SUBDIVISION COMMITTEE
METROPOLITAN AREA PLANNING COMMISSION

STAFF REPORT
(Preliminary Plat)

CASE NUMBER: S/D 88-89 - Westwood Village 4th Addition

STAFF REPORT
(Final Plat, Preliminary Plat Approved 10/06/88)

VICINITY MAP:

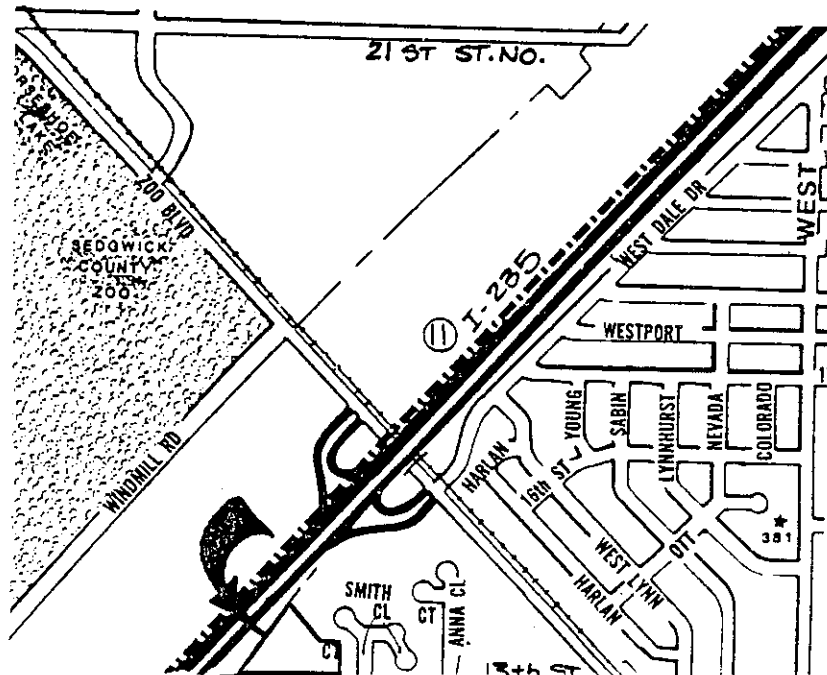
- A. Since this property is being platted for the development of single-family homes, the applicant shall request that this property be down-zoned to the "AA" zoning district. Approval of this preliminary plat is subject to approval of this zone change case.

- B. The applicant shall guarantee the extension of City water to serve the lots being platted.
- C. The applicant shall guarantee the extension of sanitary sewer to serve the lots being platted.

- D. The applicant shall guarantee any drainage improvements required by the platting of this property.
- E. The applicant shall guarantee construction of the storm sewers required by this plat.

- F. The applicant shall guarantee the paving of the proposed interior streets.
- G. The applicant shall guarantee the paving of the unpaved portion of 13th Street to the west line of Lot 1. *shall include sidewalk*

- I. The applicant shall submit an avigational easement covering all of subject plat and a restrictive covenant assuring that adequate construction methods will be used to minimize the effects of noise pollution in the habitable structures constructed on subject property.

- J. The final plat shall indicate the platting of a 25-foot front yard building setback for Lots 1 thru 18 on the respective 13th Street Courts.
- K. The final plat shall indicate a 25-foot "building setback and utility easement" adjacent to the south line of Lots 1, 5, 6, and 18.

- L. The final plat shall indicate the platting of "complete access control" to 13th Street North across the south line of the plat, from Lots 1, 5, 6, and 18. Also, the final plat shall indicate the platting of "complete access control" to I-235 across the west line of the plat, from Lots 1, 2, 3, 10, 11, and 12.

- M. Prior to, or at the time of submitting the final plat, the applicant shall submit a drainage plan to City Engineering for review and approval.
- N. Requirements for a final plat (see pages 20-25, Part 4, Article 5 of the MAPC Subdivision Regulations).

VICINITY MAP:

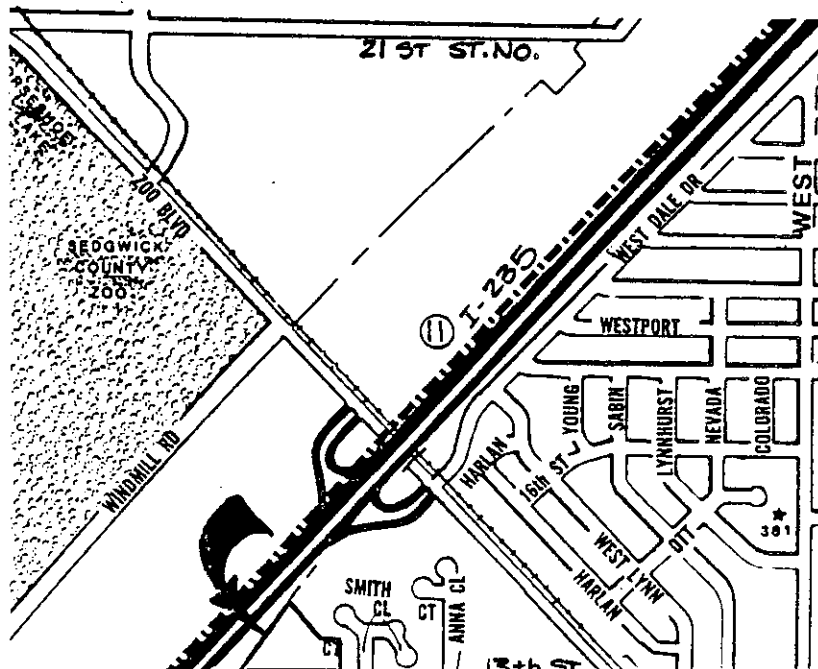
- A. Since this property is being platted for the development of single-family homes, the applicant shall request that this property be down-zoned to the "AA" zoning district. Approval of this preliminary plat is subject to approval of this zone change case.

- B. The applicant shall guarantee the extension of City water to serve the lots being platted.
- C. The applicant shall guarantee the extension of sanitary sewer to serve the lots being platted.

- D. The applicant shall guarantee any drainage improvements required by the platting of this property.
- E. The applicant shall guarantee construction of the storm sewers required by this plat.

- F. The applicant shall guarantee the paving of the proposed interior streets.
- G. The applicant shall guarantee the paving of the unpaved portion of 13th Street to the west line of Lot 1. As required for a collector, this guarantee shall include a sidewalk along the north line of 13th Street, adjacent to the area requiring paving.

- I. The applicant shall submit an avigational easement covering all of subject plat and a restrictive covenant assuring that adequate construction methods will be used to minimize the effects of noise pollution in the habitable structures constructed on subject property.

- J. The applicant shall install or guarantee the installation of all utilities and facilities which are applicable and described in Article 8 of the MAPC Subdivision Regulations.
